City of Santa Fe, New Mexico

2025-10037 1111 Ocate Road Attachment B

Development Review Team

Development Review Team (DRT) Comment Form

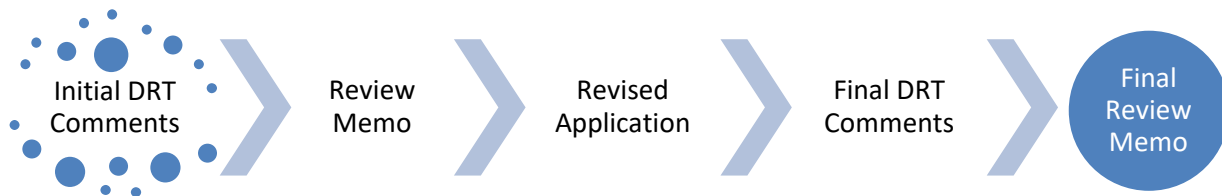
The blue line below shows the sidewalk shown in the plan set. The red lines show the additional sidewalk and crosswalk needed to make a continuous pedestrian connection to Cerrillos Road.
